## **Elder Street Improvement project, Phase 2 (Addendum #1)**

In accordance with the requirements of the "Instructions to Bidders," this Addendum shall be attached to and become a part of the Contract Documents for the above referenced project.

TYPICAL CROSS SECTION  
 ( NO SCALE )

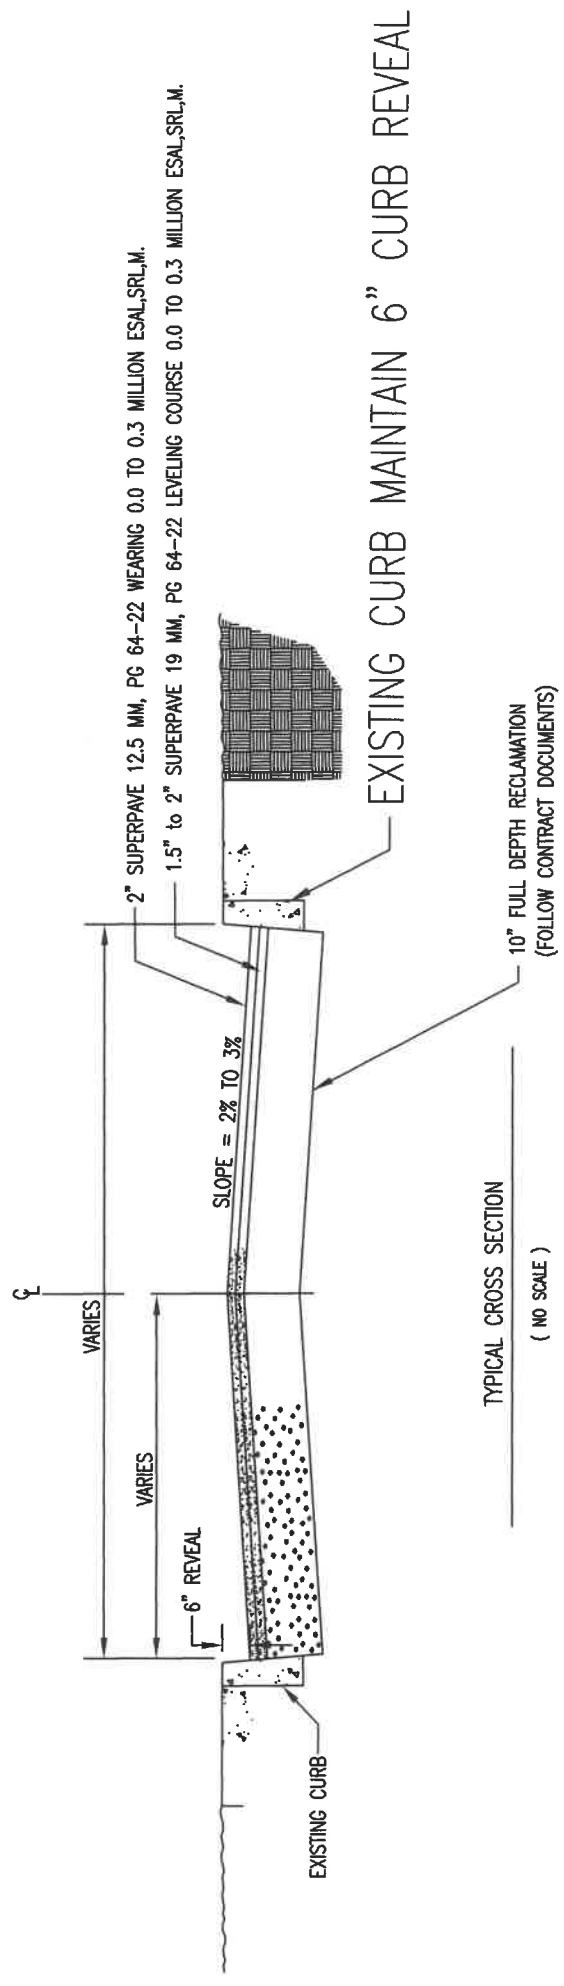
- 1) The opening date is being changed to **10:00 a.m., on THURSDAY MAY 9, 2019**. Any Bid received after said date and time will be returned unopened. All Bids must be in a sealed envelope clearly marked "Bid for Borough of Chambersburg", bearing the name of the Bidder and "ELDER STREET IMPROVEMENT PROJECT, PHASE 2." If the Bid is sent through the mail or other delivery system, the sealed envelope shall be enclosed in a separate envelope with the notation "BID ENCLOSED" on the face of it. Please mail Bids to Attention: Jamia L. Wright, Borough Secretary.
- 2) Please find attached cross section exhibit depicting scratch coat.
- 3) Excavated material may be deposited at the Borough Farm off Hollywell Avenue.

2" SUPERPAVE 12.5 MM, PG 64-22 WEARING 0.0 TO 0.3 MILLION ESAL,SRL,M.  
 1.5" to 2" SUPERPAVE 19 MM, PG 64-22 LEVELING COURSE 0.0 TO 0.3 MILLION ESAL,SRL,M.

SLOPE = 2% TO 3%

EXISTING CURB MAINTAIN 6" CURB REVEAL

10" FULL DEPTH RECLAMATION  
 (FOLLOW CONTRACT DOCUMENTS)
